### Oregon Water Resources Department

#### REQUEST FOR WRITTEN APPROVAL TO USE CONSTRUCTION METHODS NOT INCLUDED IN OREGON ADMINISTRATIVE RULES 690-200 THROUGH 690-240

(2) Start Card Number(s): 149726

(7) Diagram showing the pertinent features of the proposed well design and construction (attach additional pages if needed)

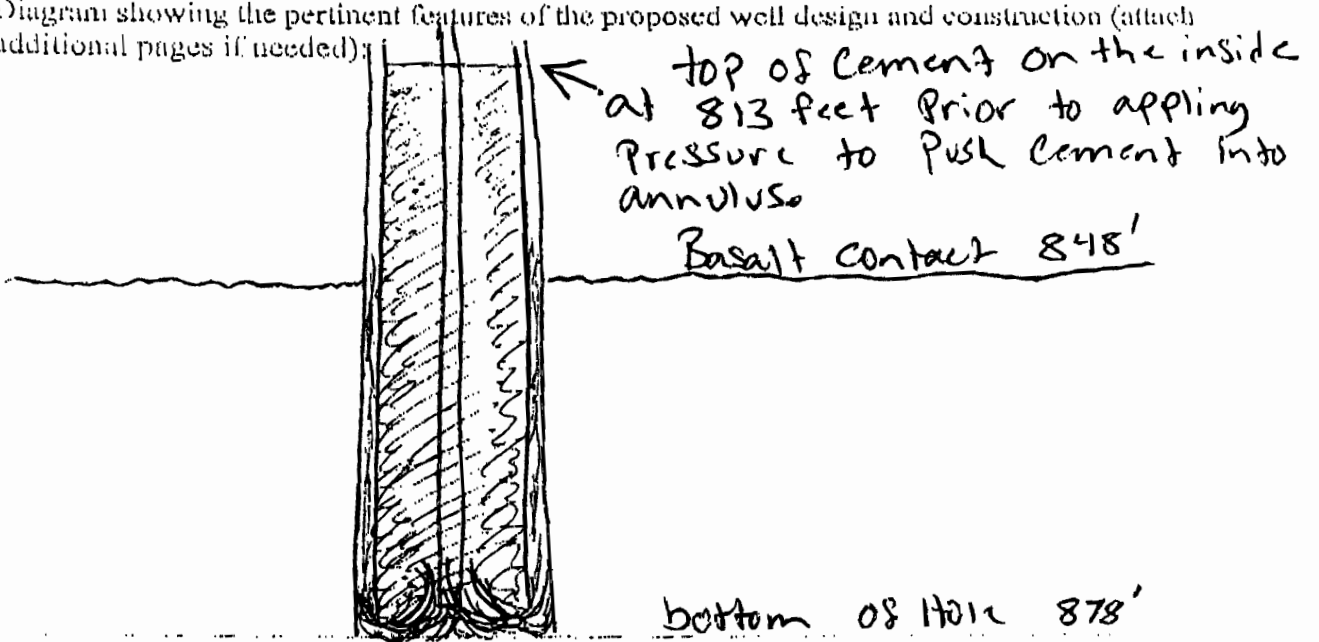
(5) The unusual conditions which necessitate this request: the need to  
install a reduced annulus seal at the  
basalt contact at 848 - 878'

(6) The proposed construction methods that the well constructor believes will be adequate for this well (attach additional pages if needed)  
Pressure Grout Cement from inside out to  
force cement into reduced annulus. Grout  
will be tremied to bottom of hole

Date: 5-16-02

Approved by: *Jacy Echenlaub* Denied by:
